Section: 501-16

Model: Galaxy 2000.75 (Build Date: 08/2001 Onwards) (Build Code: 1G Onwards)

Subject: Front wiper blades touch left and right A-pillar when the windshield wipers are switched on

TIE44760

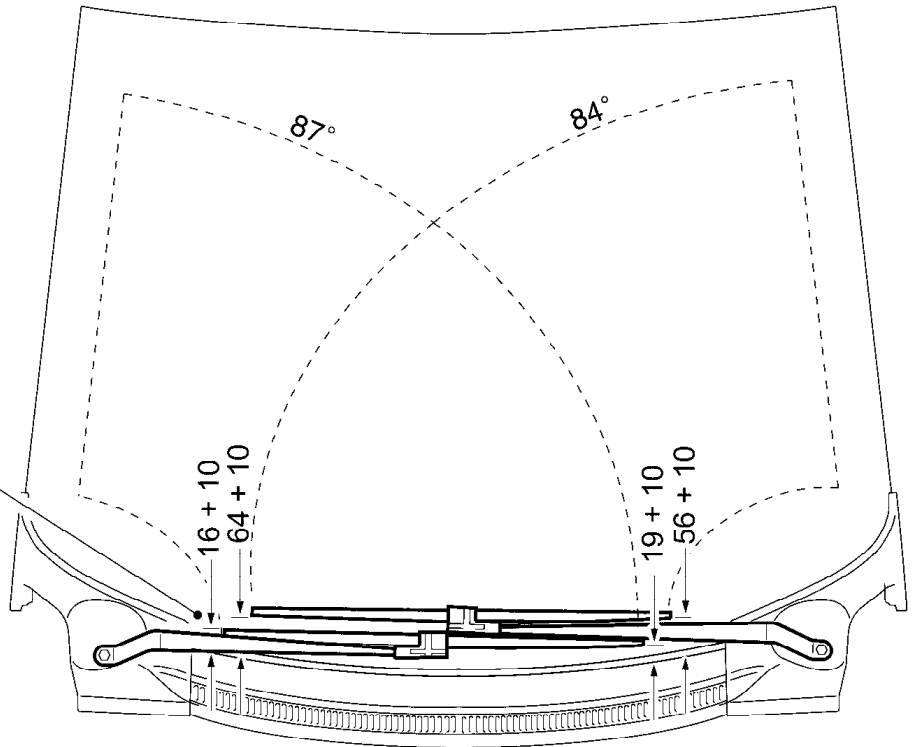
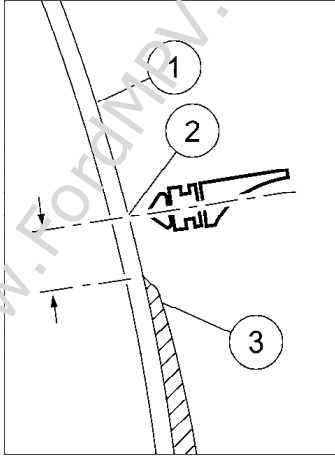
Install the windshield wiper arms in their revised positions.

Before installation, thoroughly clean the splines of the windshield wiper arms and the tapers using a suitable cleaning agent, to avoid an incorrect adjustment.

Item	Description
1	Windshield
2	Point of windshield wiper blade
3	Cowl panel
